ADDENDUM NO. 1

FESTIVAL PIER BOAT RAMP AND SITE IMPROVEMENTS PROJECT PAWTUCKET, RI

March 6, 2014

Fuss & O'Neill, Inc.
317 Iron Horse Way, Suite 204
Providence, RI 02908

CS-101

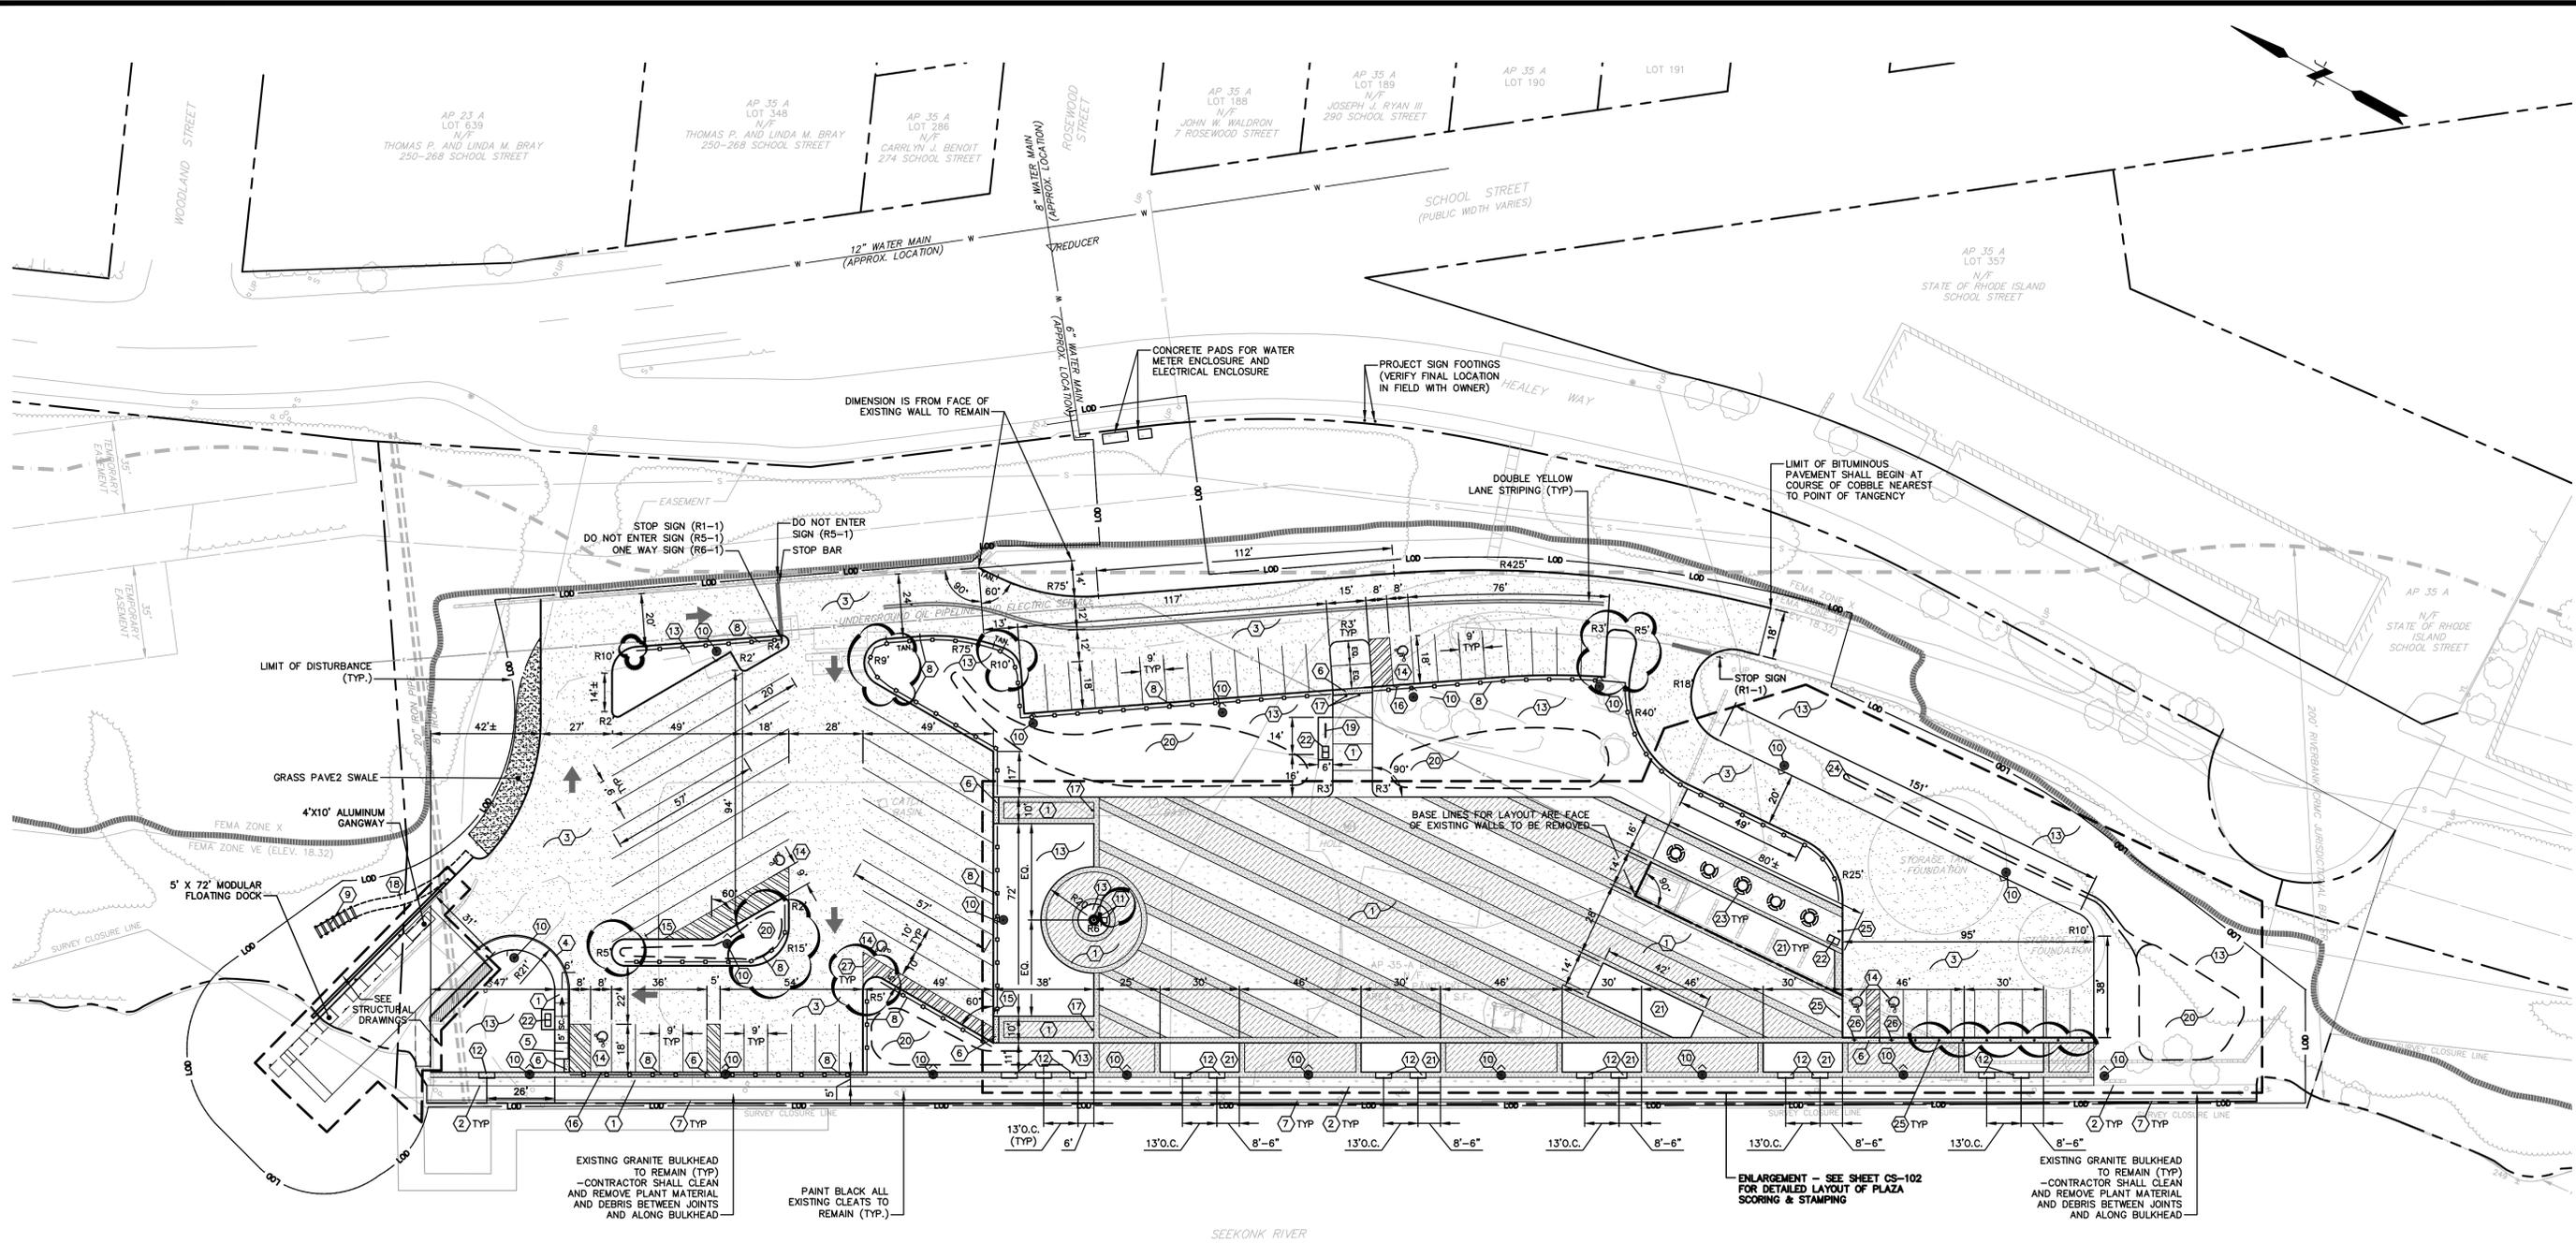
12. **Question:** Drawing CS-101, Item 25 Bollards: The arrow showing the location of the bollards is in a hatched area. The bollards are not visible. Please clarify the location and quantity of bollards.

24. **Question:** Where is the proposed location for the existing monument? It's now shown on Drawing CS-101. Is there a detail for resetting the monument?

32. **Question:** From our guardrail supplier: There is a potential problem with the radius points called out for the wood guardrail. Since the rails need to slide through the posts, as called out in the details, you would not be able to achieve the required curvature called out in the plans. You can shrink the post spacing down in the larger curves, but the tight radiuses would still pose a problem. Please advise.

Response: The quantity of bollards to be installed shall be in accordance with Unit Bid Base Bid Item 12. The location of the bollards within the area in question shall be in accordance with sheet CS-101, attached as Figure 1.

Response: The proposed monument shall be located in front of the proposed flag pole as shown on Figure 1. Monument setting shall be replaced in-kind.

Response: Post spacing may be reduced to 6 feet around the tighter curves. Post shall be evenly spaced (at 10 feet max) for straight runs. Sections of guiderail located adjacent to Sand Filter 1, Sand Filter 2, and to the east of Sand Filter 4 have been removed. See Figure 1 and Bid Form included in Exhibit B.

CU-101

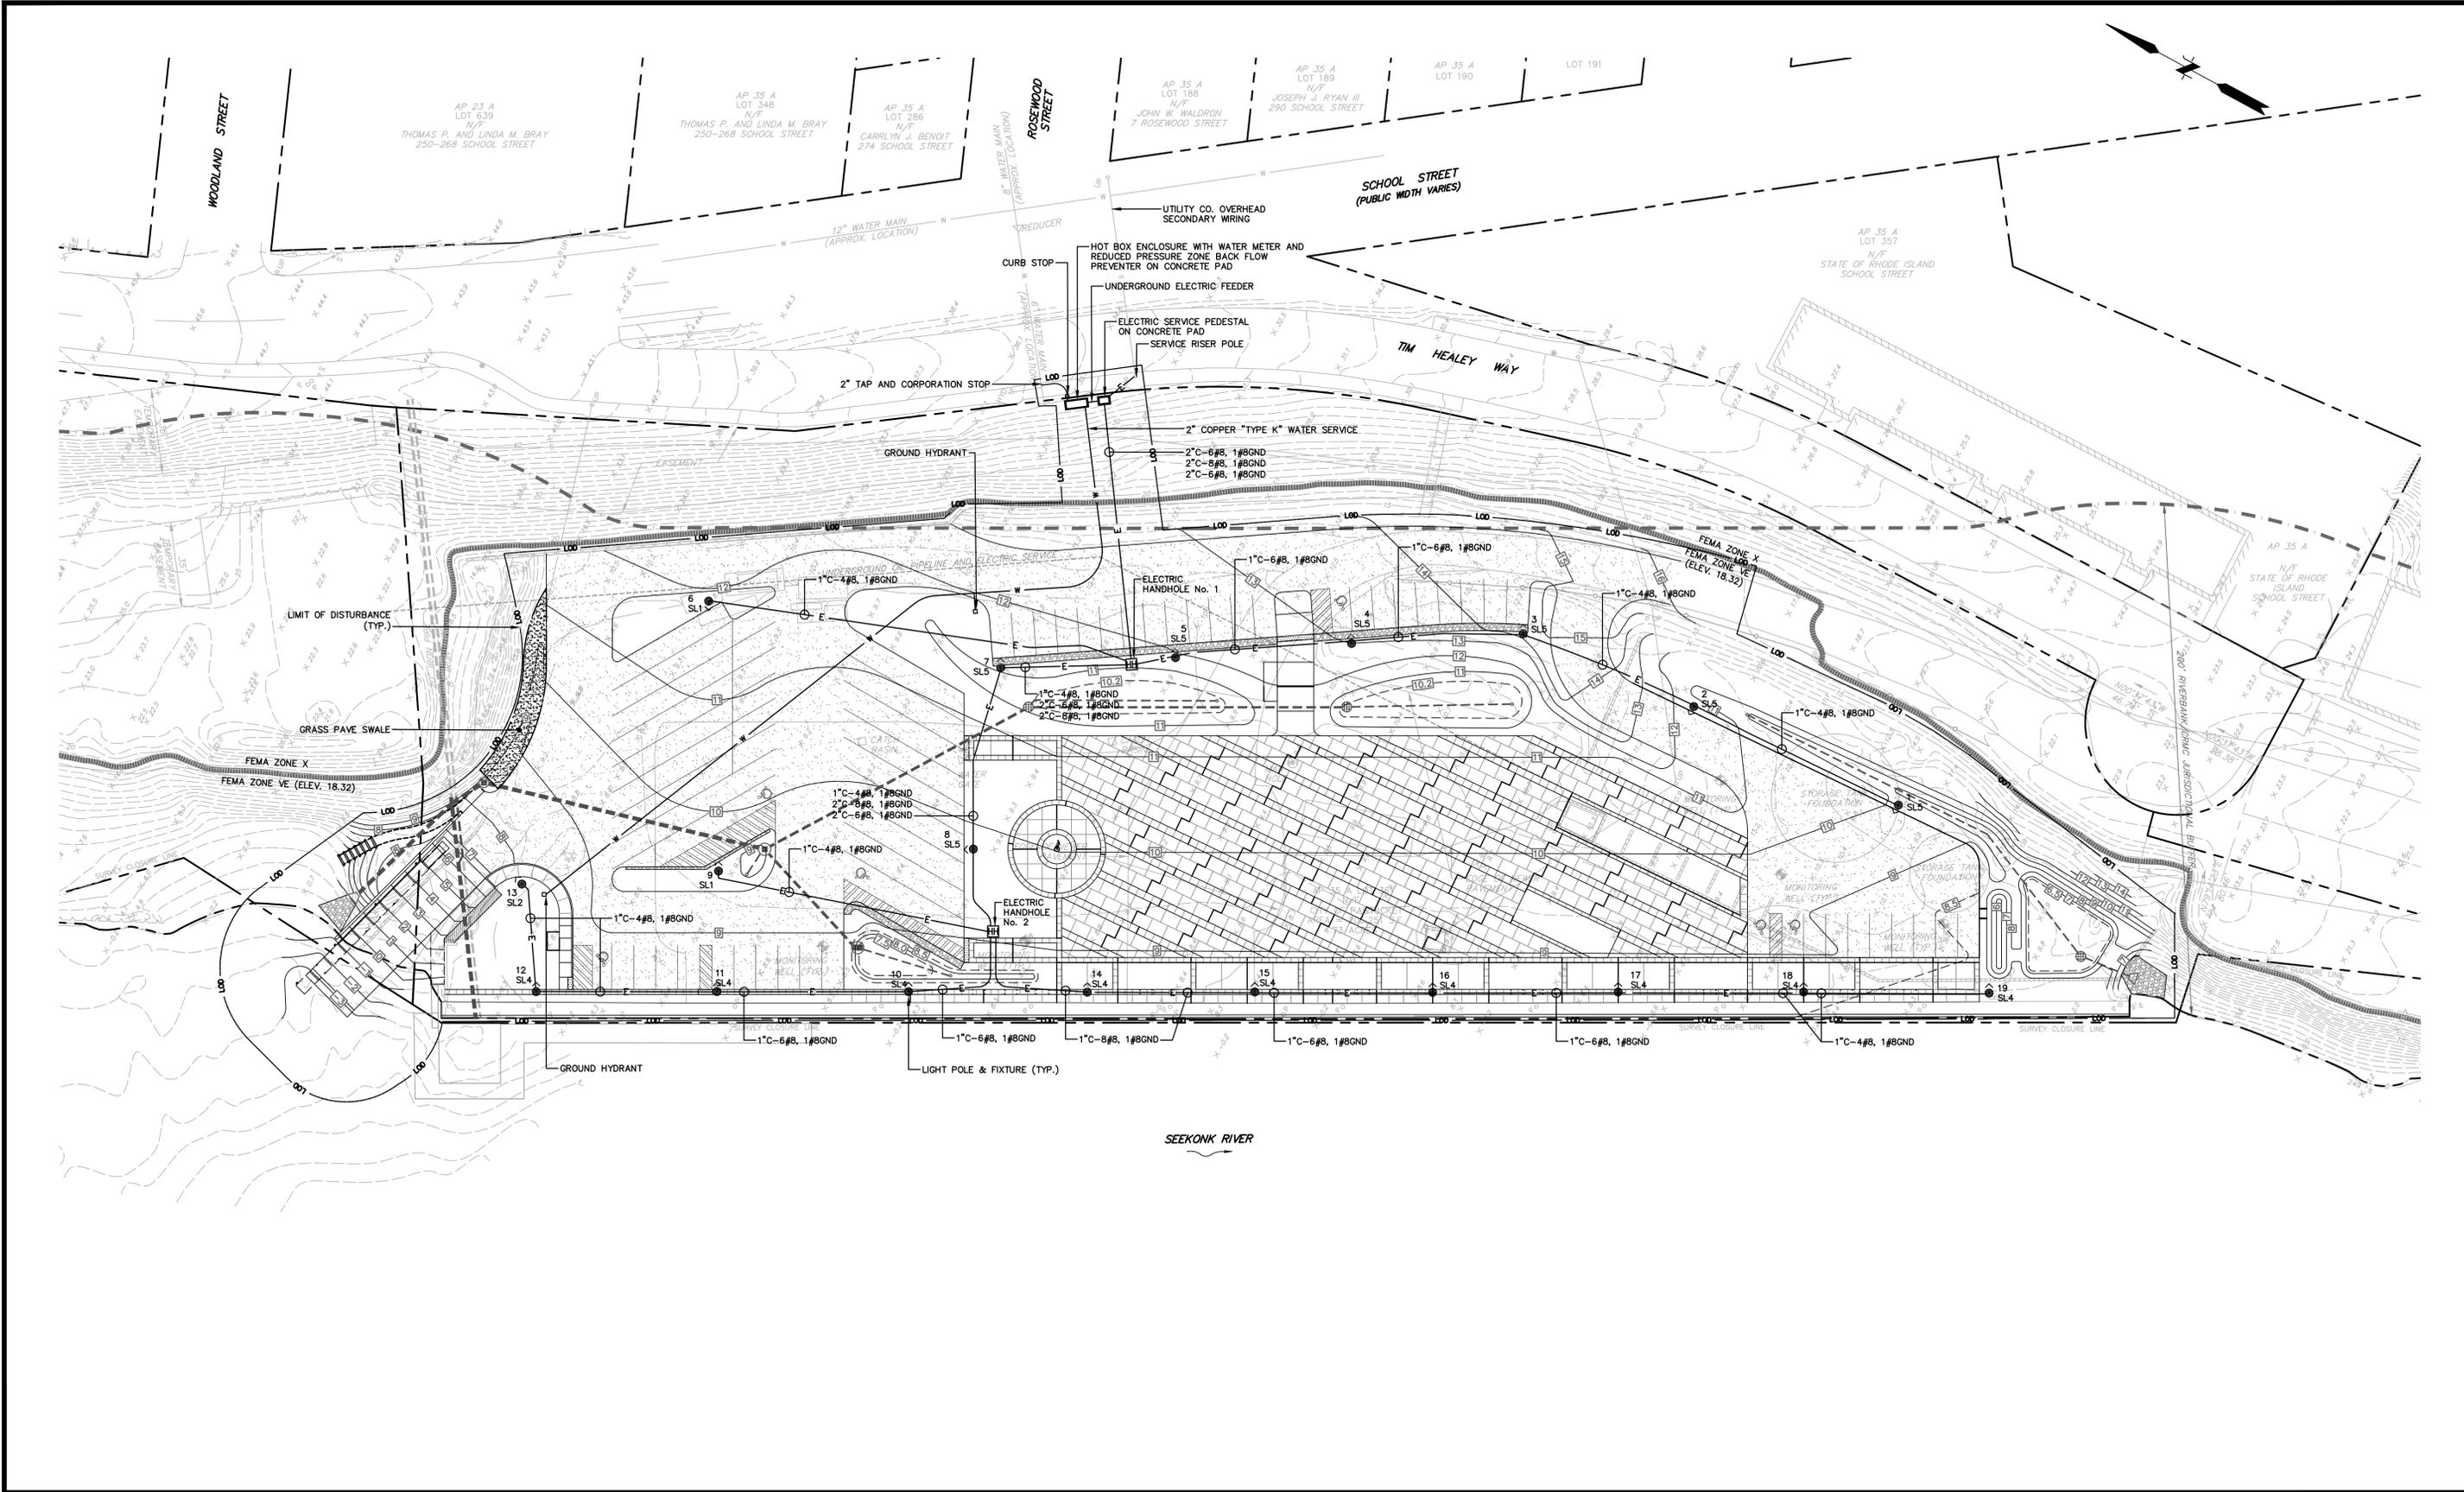
35. **Question:** How many lights are there? Print cd-509 shows 21 lights (listed on circuit layout). Print cu-101 shows 19 lights. Spec's call for 19 lights.

36. **Question:** What size conduit to each pole? Print cd-509 shows conduit coming out of panel and time clock as 2" conduit going to all poles with (6) #8 and (1) #8 ground. Then it shows it as individual runs of 1" conduit (between light pole 7 and light pole 10). spec's call for 1,667.00 feet of 2" and only 22' of 1". I can't see how you can fit (2) 2" in each light pole.

Response: There are 19 lights. See attached Figure 3, Figure 8, and Bid Form included in Exhibit B.

Response: See Figure 3, Figure 8, and Bid Form included in Exhibit B.

PROJ. No.: 20090081B11
 DATE: SEPTEMBER 2012
LP-101

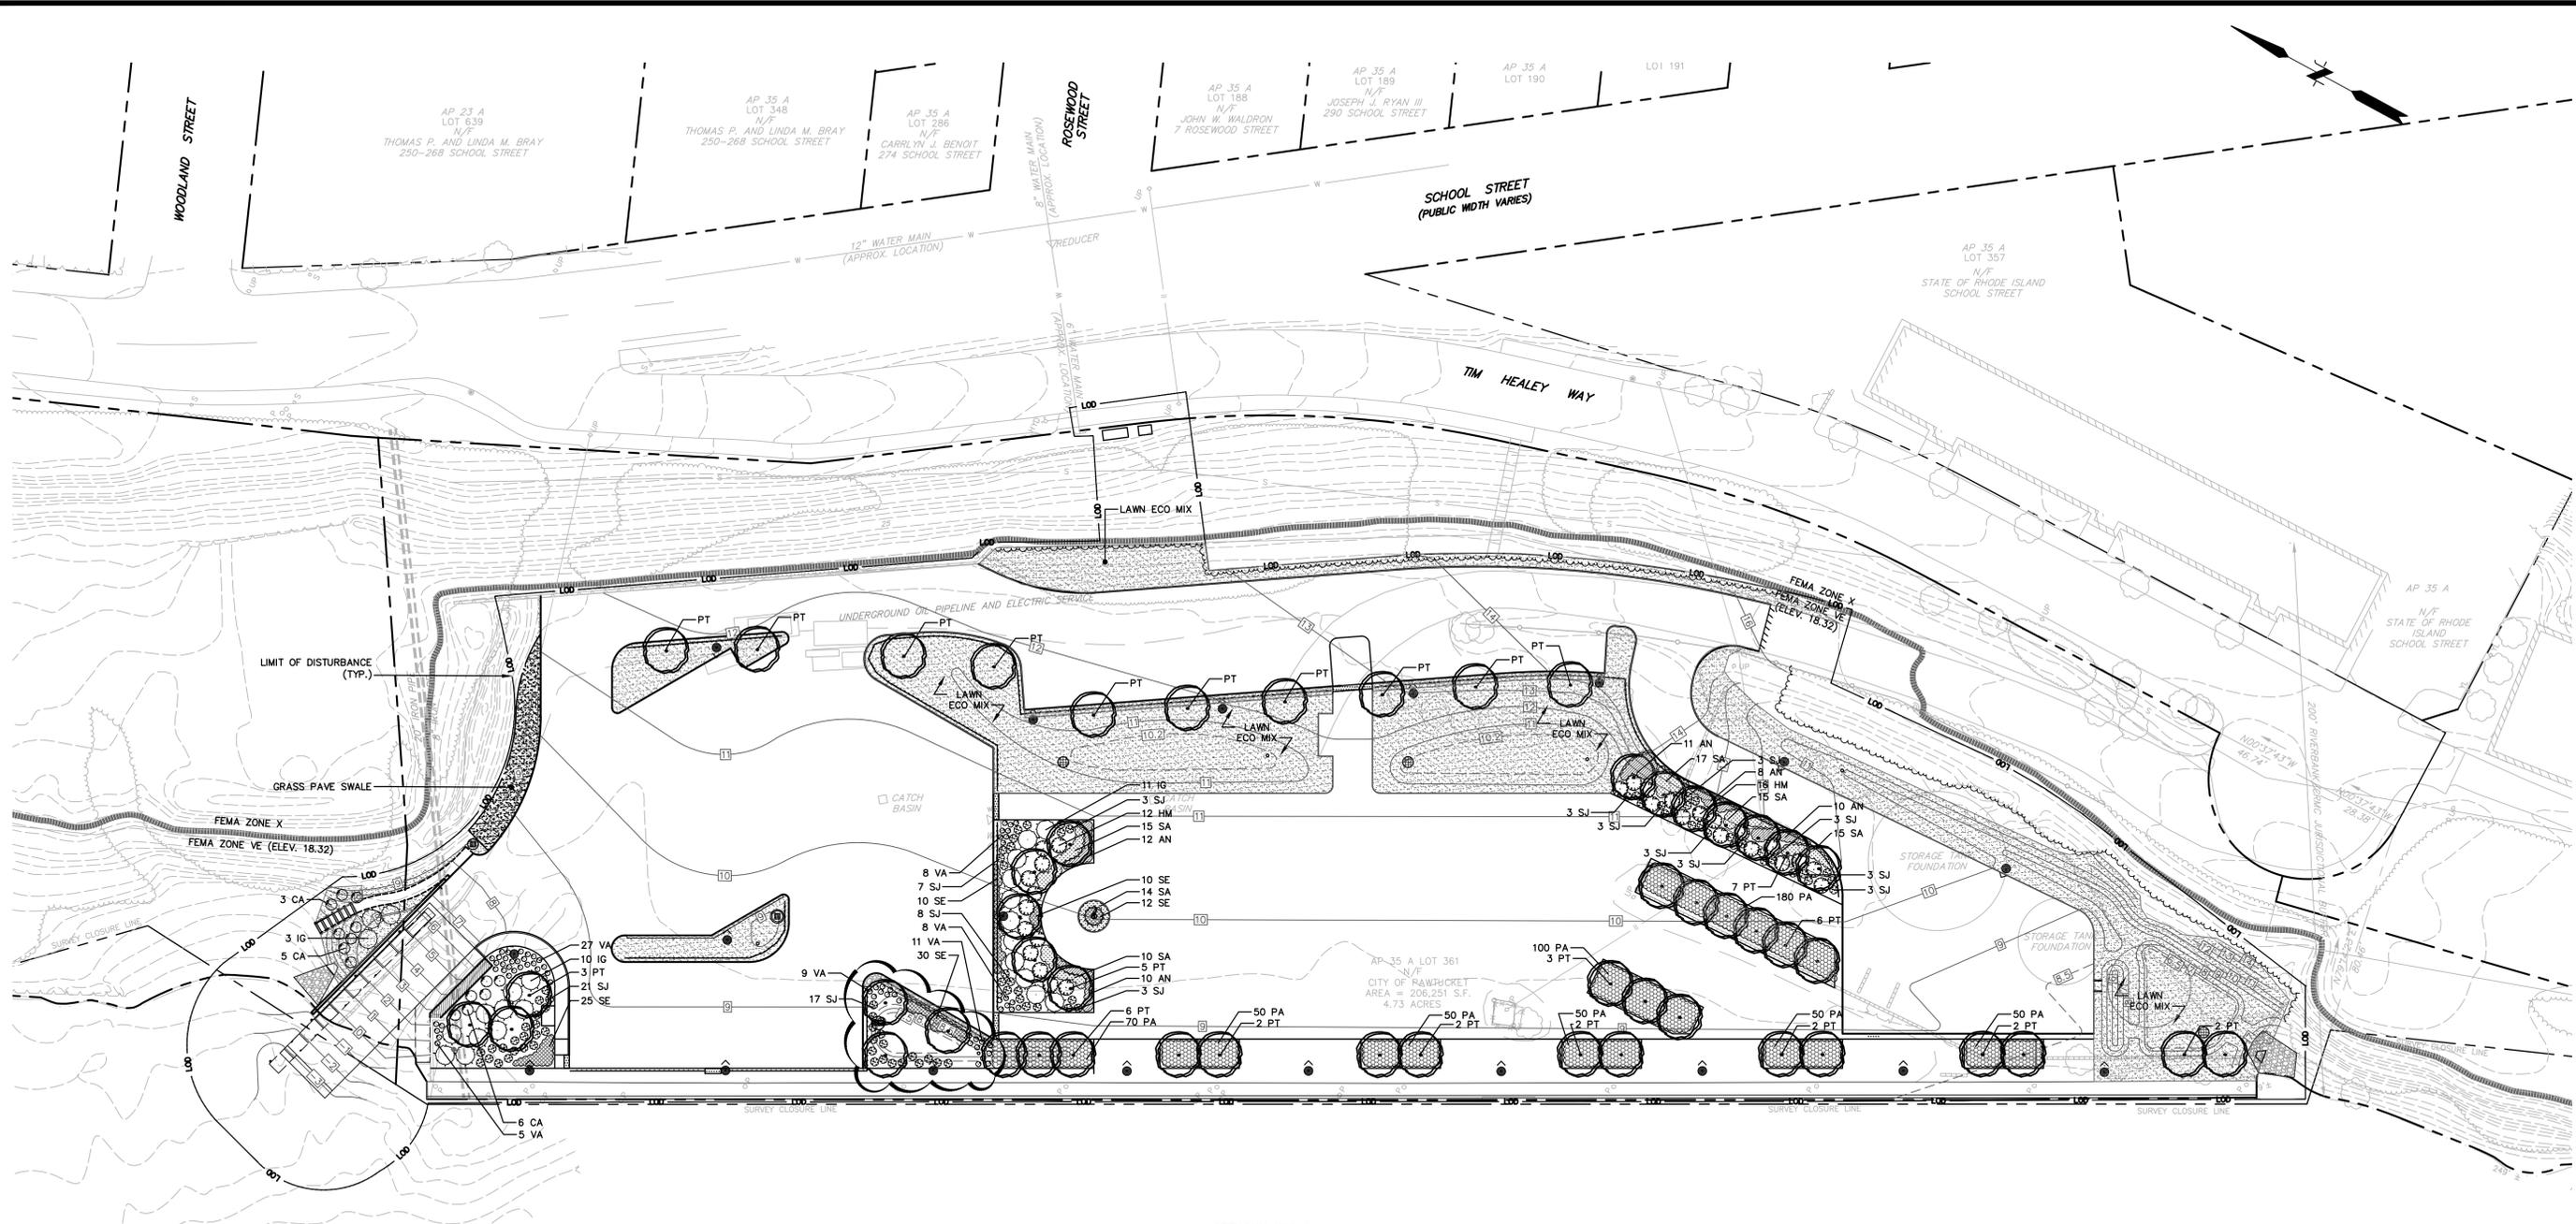
29. **Question:** Sand Filter No. 2; trees & shrubs are planted in the sand filter.

Response: Shrubs shall be located above the impermeable liner. Trees have been relocated outside the limit of the filter bed. Inkberry shrubs have been removed from the filter bed. See [Figure 5](#) and Bid Form included in [Exhibit B](#).

LIGHT POLE FOOTING
SCALE: N.T.S.

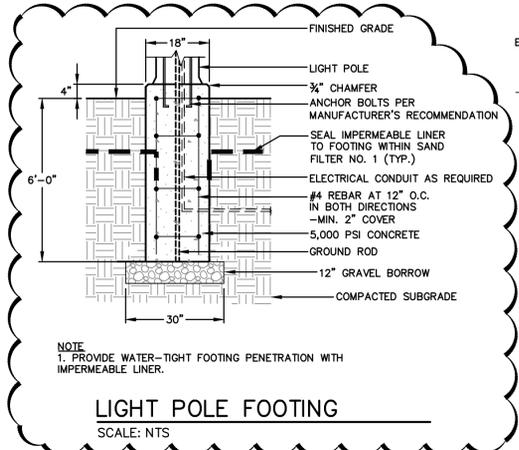
- a. There is a light pole base in the sand filter. The bottom of gravel is 7 ft down from finish grade. This will penetrate the impermeable liner. Please provide a detail of the impermeable liner at the light pole base.
- b. There is a Timber Guardrail around the perimeter of the sand filter. The bottom of the posts are 18" down from finish grade. These will penetrate the impermeable liner. Please provide a detail of the impermeable liner at the posts.

Response: Provide a water-tight seal with impermeable liner at point of penetration of light pole base as shown on Figure 6. The guardrail is not located within the filter bed of the sand filter. There will be no penetrations of the liner.

SUBDRAIN CLEANOUT
SCALE: N.T.S.

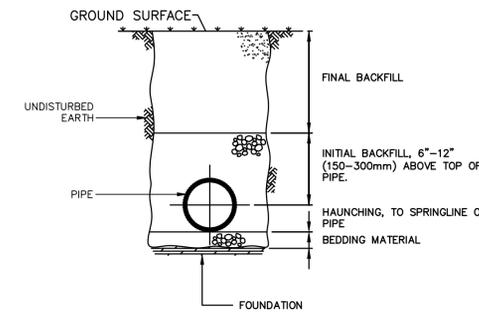
4. **Question:** Concerning the subdrain cleanouts for the sand filters. I was unable to find a detail, would you be able to specify what you would like to see for this item?

Response: Provide subdrain cleanout as shown on Figure 7.
